JULY 30, 2025

CONTRACT NO. 1800

WET WEATHER PUMP STATION

ADDENDUM NO. 6

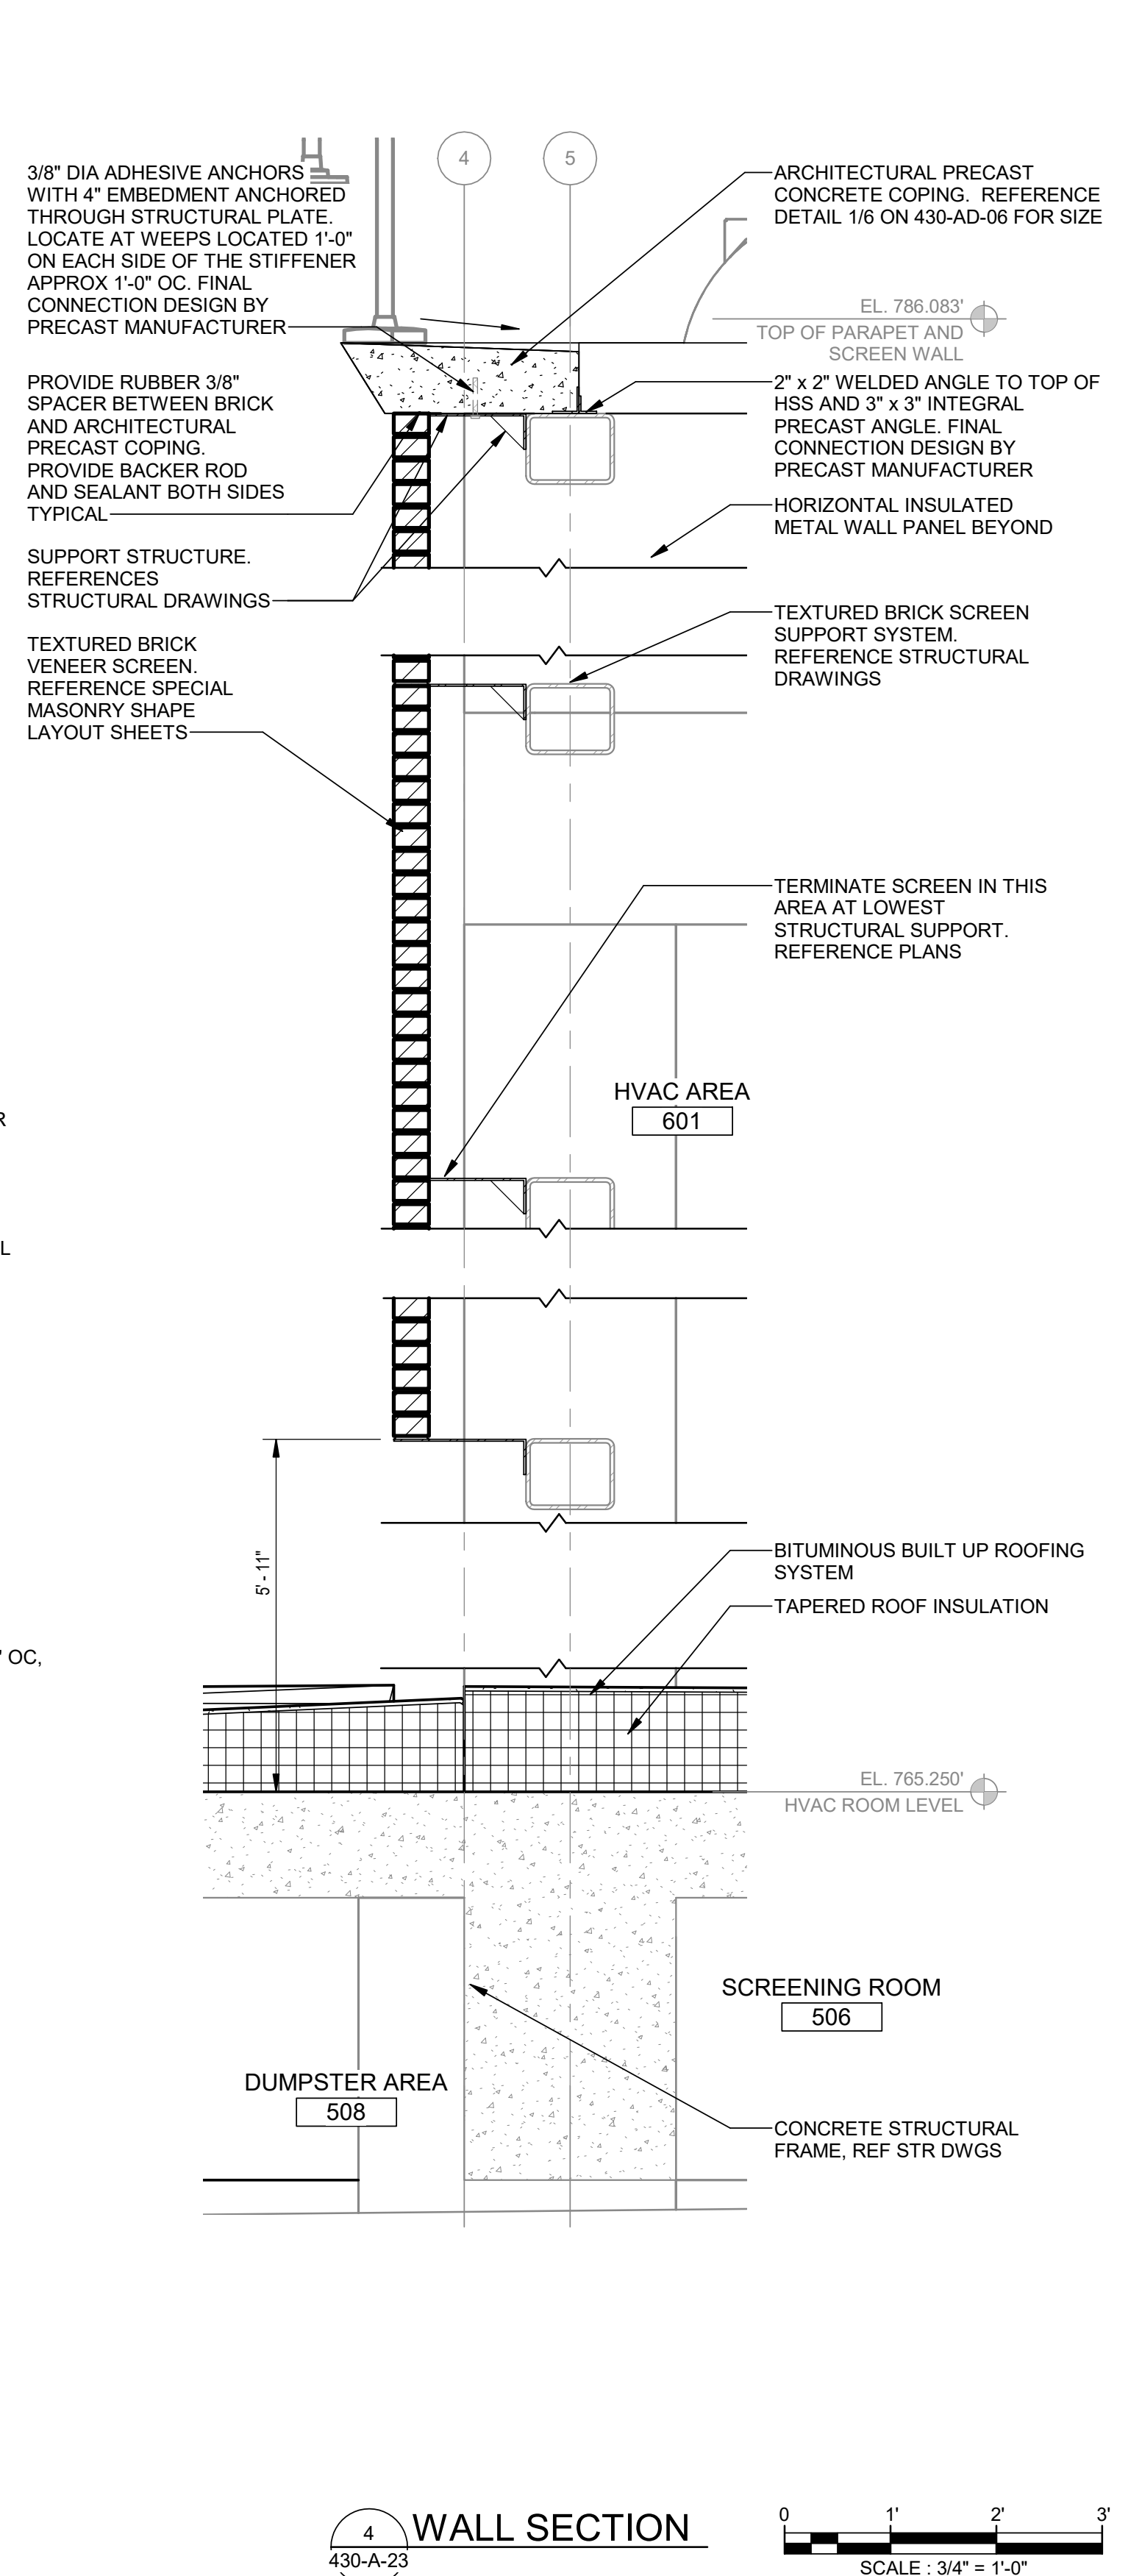
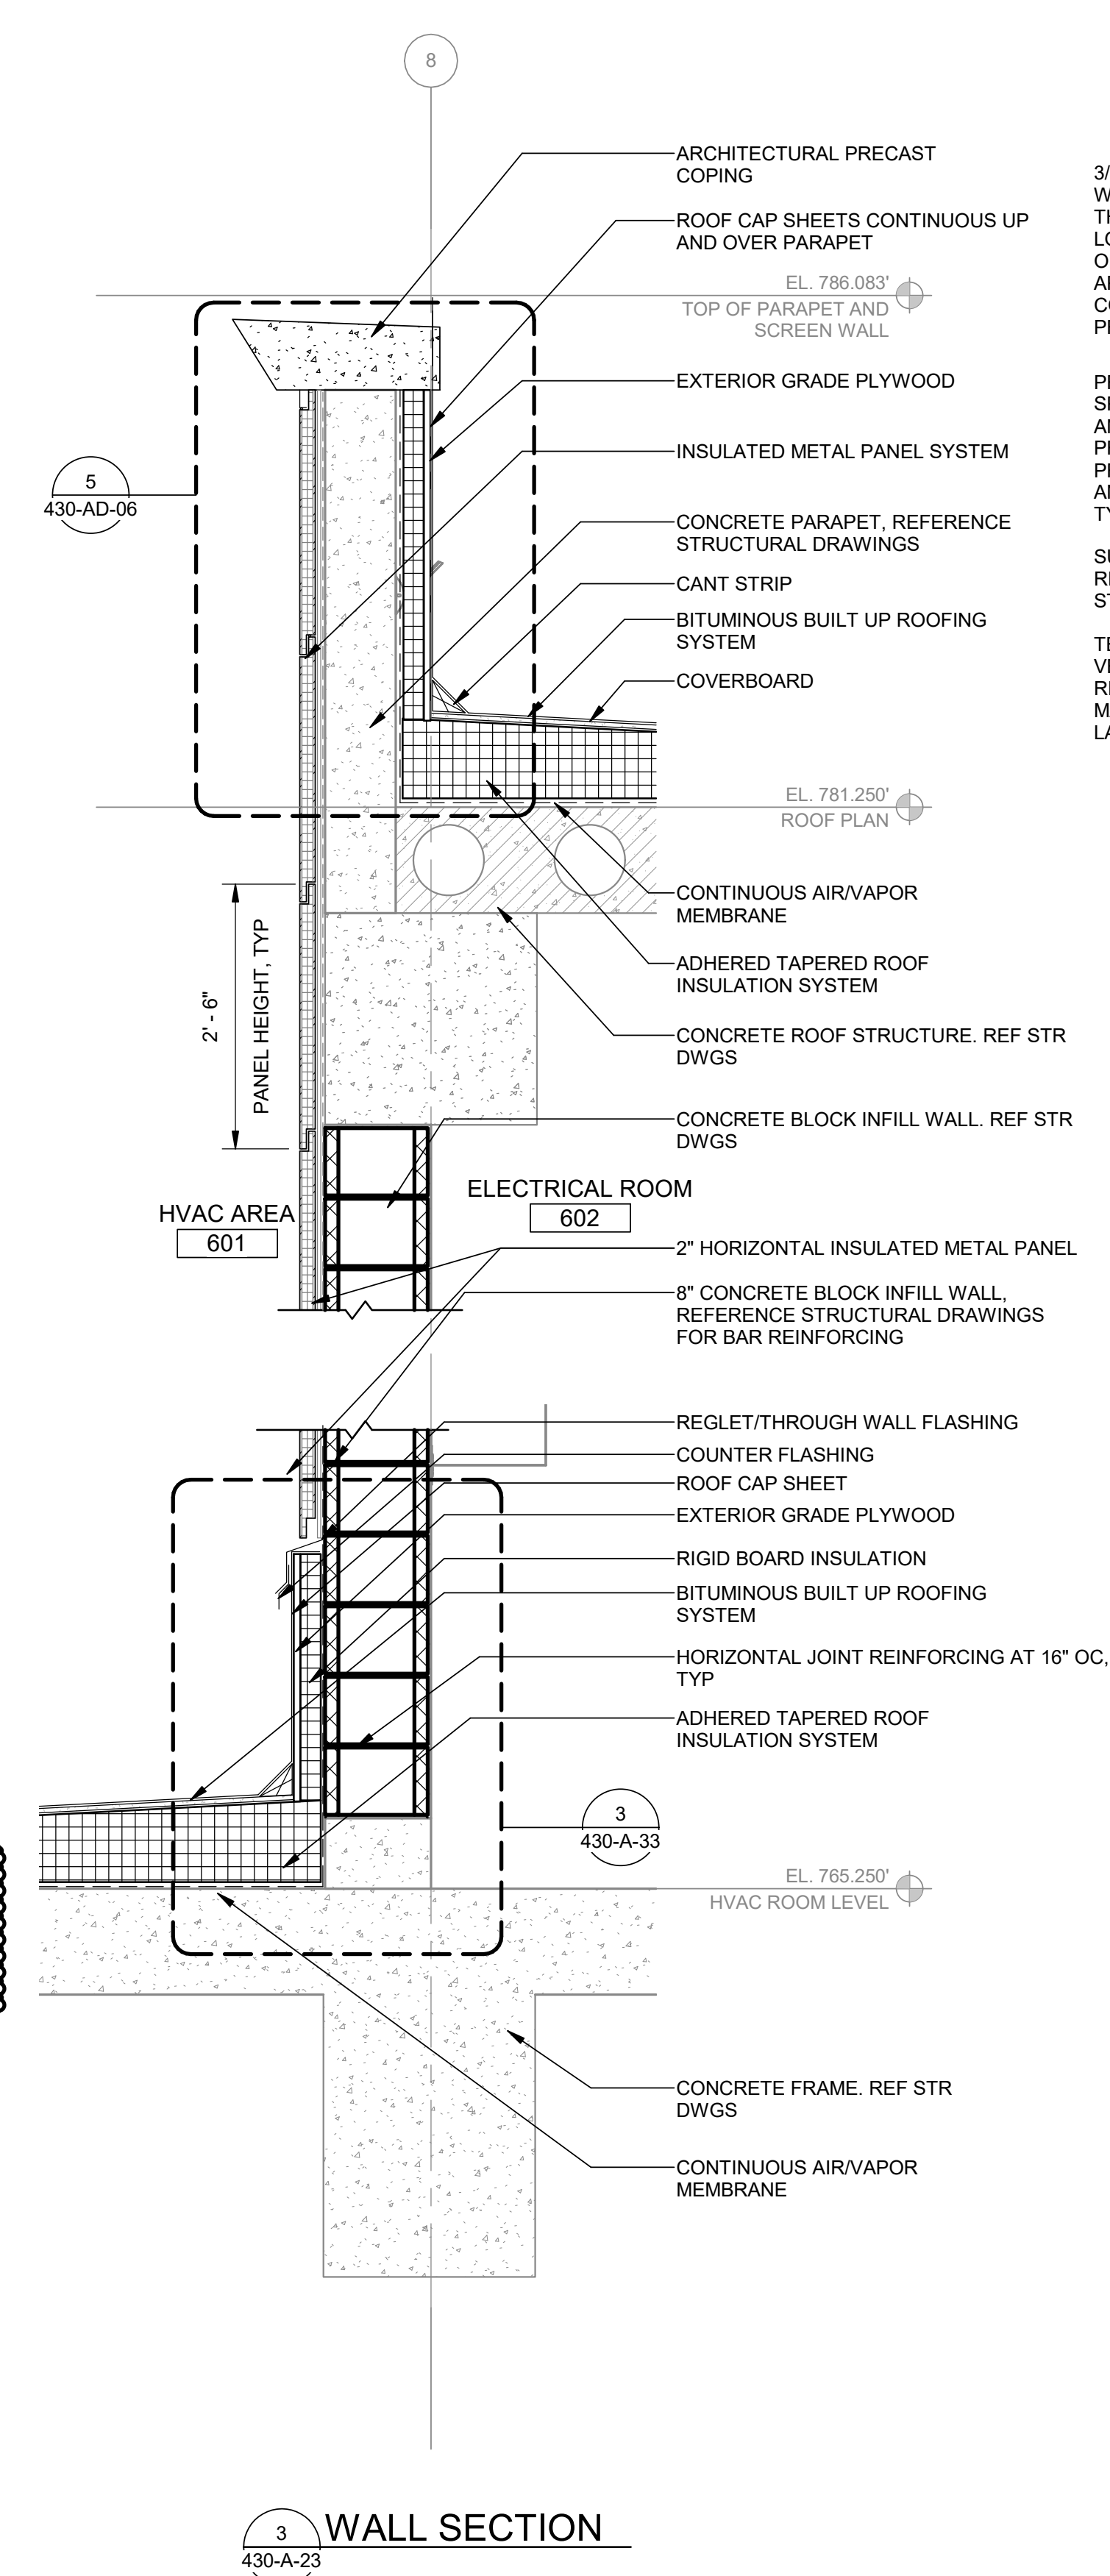
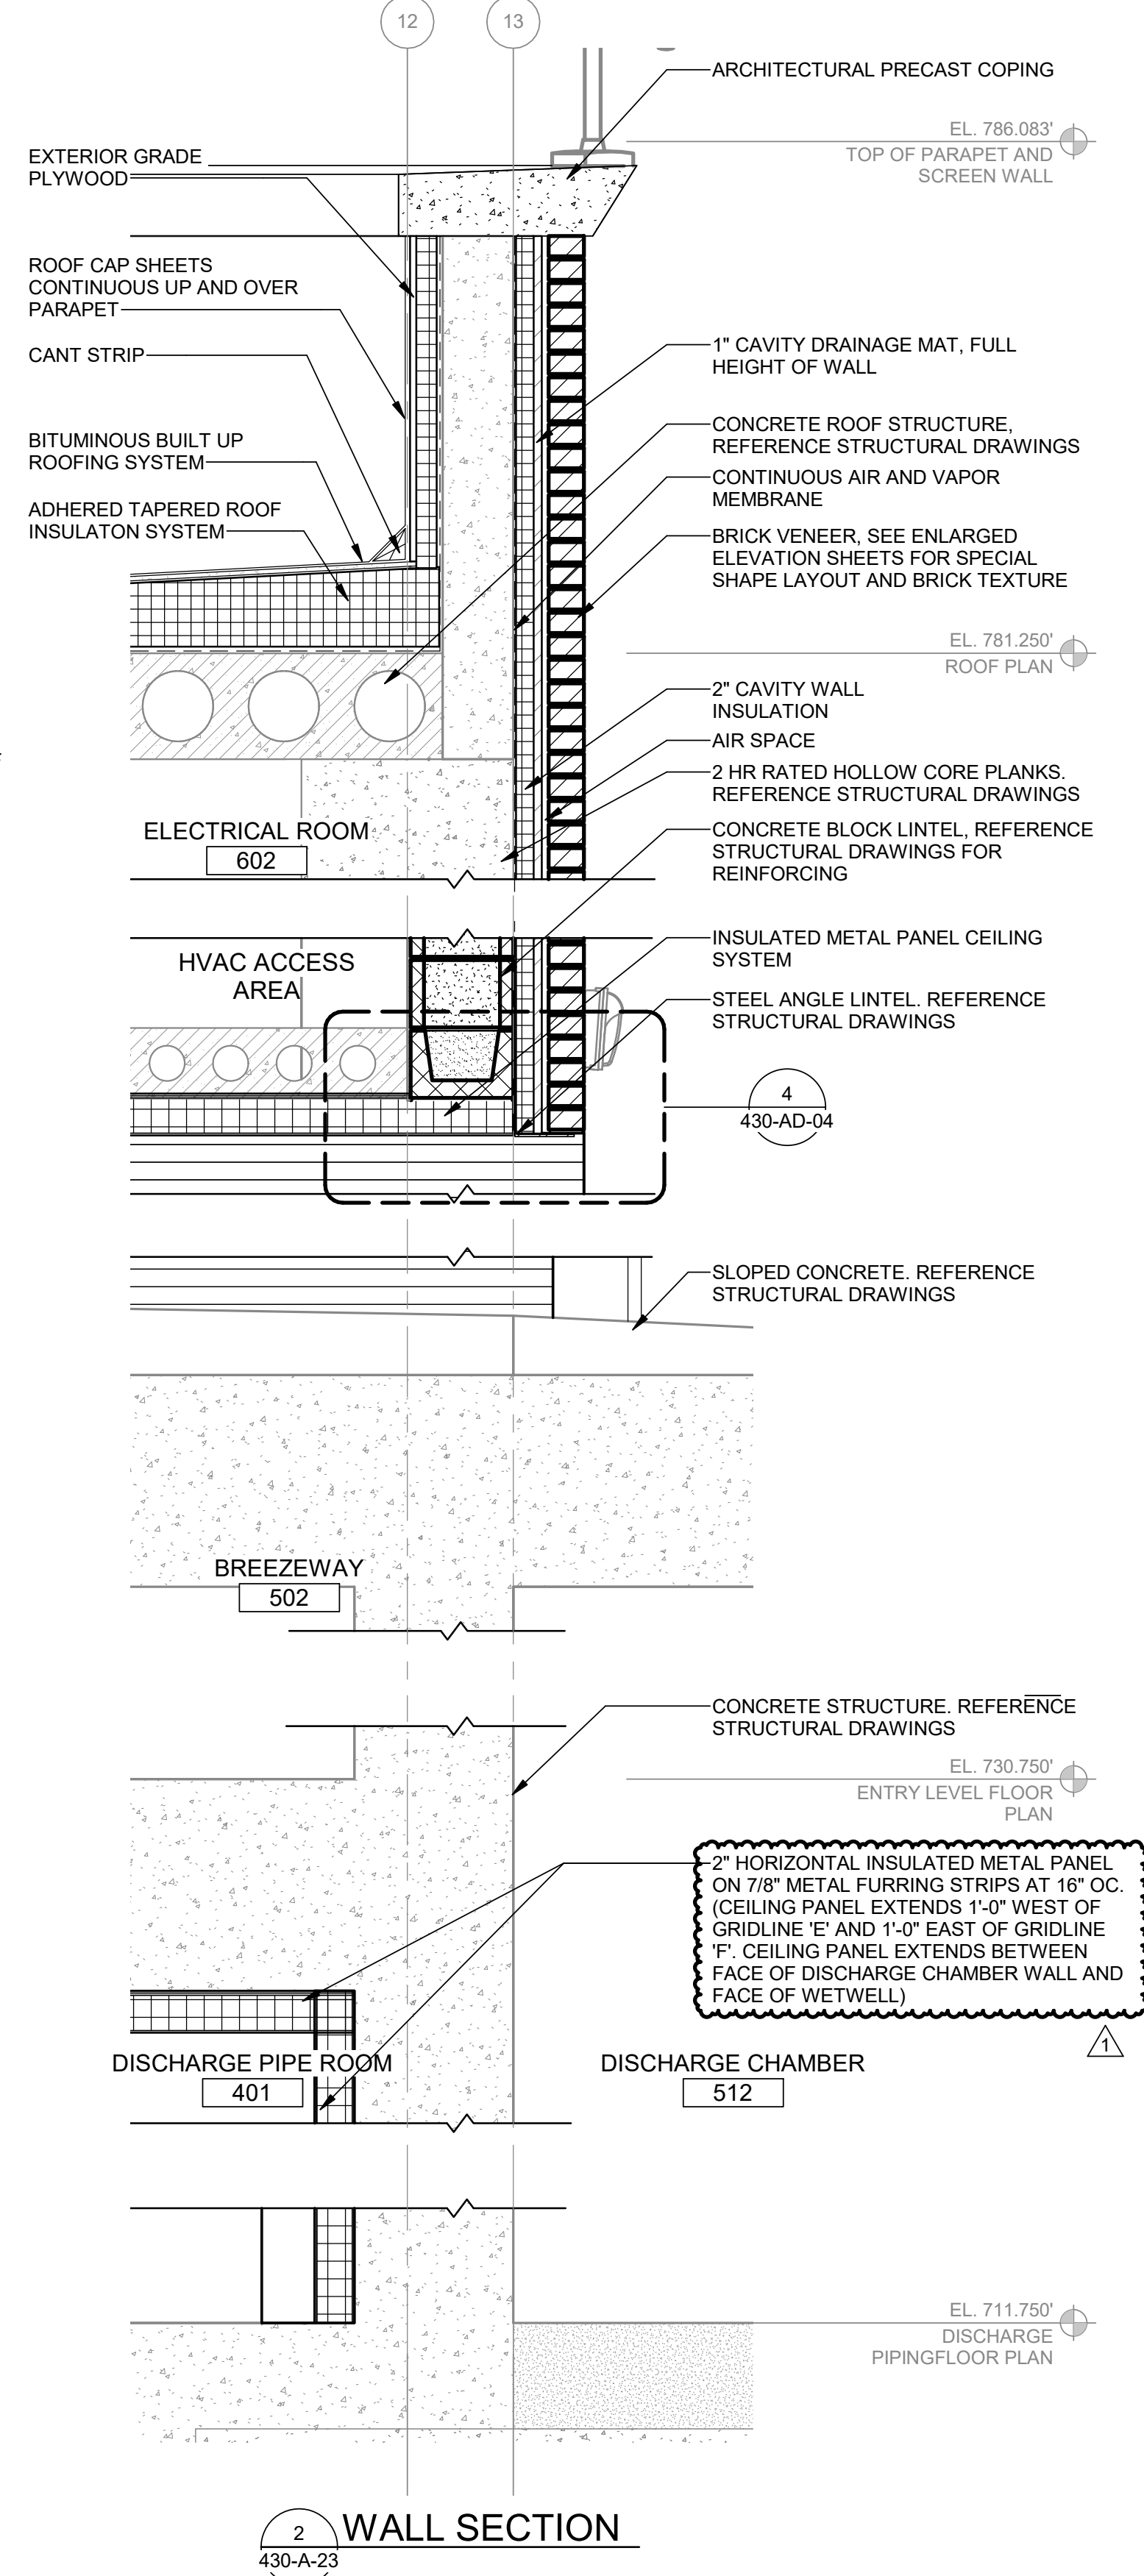
Q48: Detail 2 on Drawing 430-A-28 shows the insulated metal panel on the walls and ceiling, while room finish schedule indicates concrete ceiling within room 401. Please clarify the ceiling finish type for room 401.

A48: In Room 401, the insulated metal panel at the ceiling is intended to provide insulation for the breezeway above. The extents of the metal panel in the east/west direction should be from 1' south of grid E and 1' east of grid F. In the north/south direction, it should extend from the wall of the wetwell at the south to the wall of the discharge chamber at the north. Refer to Item 4.2 of Addendum No. 6.
